China Business Trip Report

PTC Visual Machine BB087

Date : 25/10 (DAY 5)

Magnet Surface Inspection Equipment Consensus Content

AOI/Operator Safety

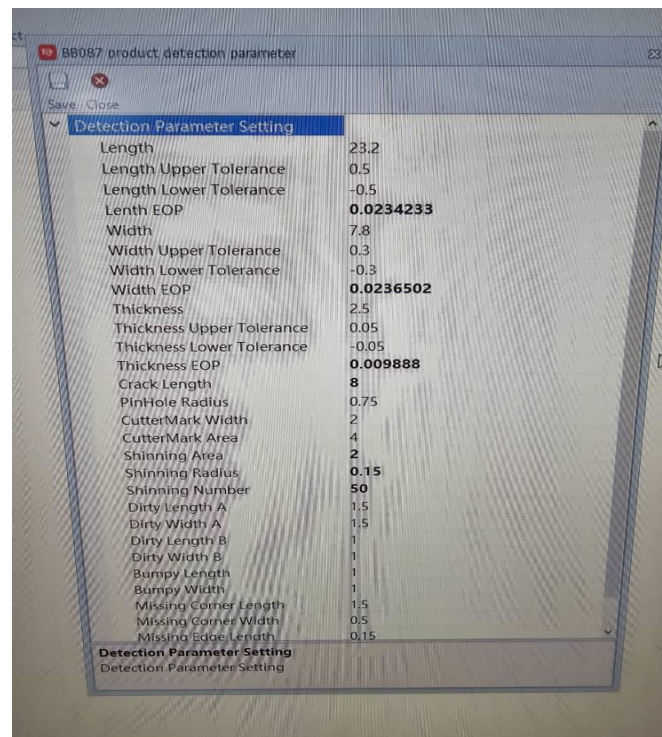
➔ PTC will include additional emergency button at output for AOI machine/ operator safety during emergency.

4. The judging criteria for Chipping are as follows:

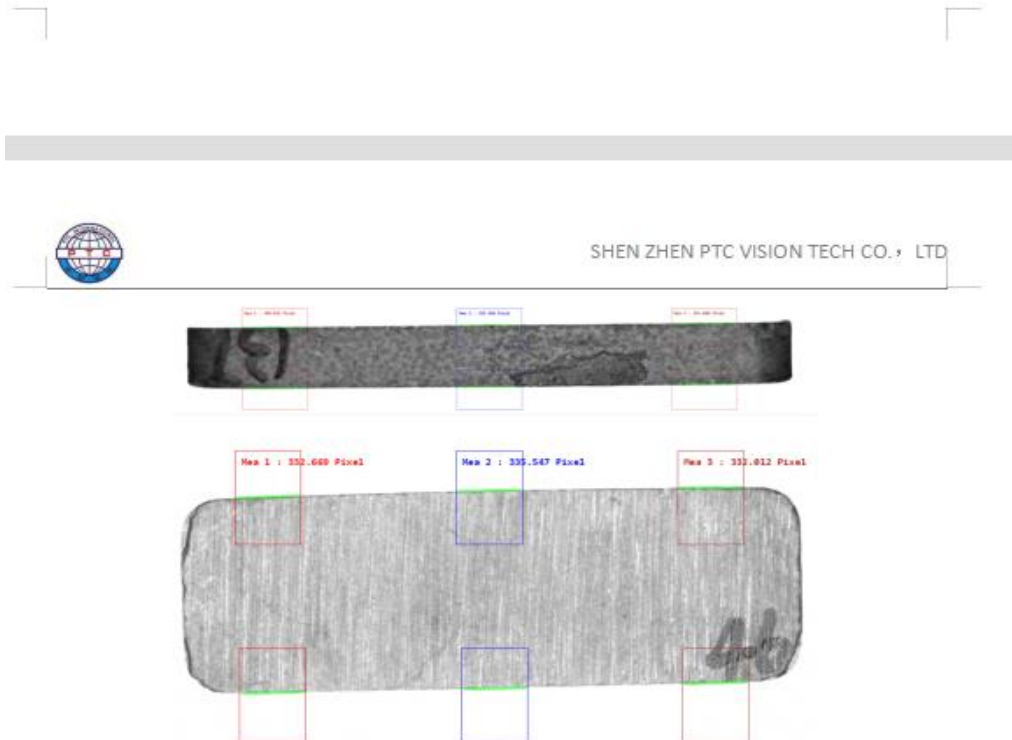
In the blue area (1.5mm) : chipping is OK regardless of size;

In the green area:

- ①chipping high $H < 0.5\text{mm}$ is OK;
- ②If the chipping height is $0.5\text{mm} < H < 1\text{mm}$ and $L < 4\text{mm}$, it is Ok;
- ③The chipping height $H > 1\text{mm}$ is NG;
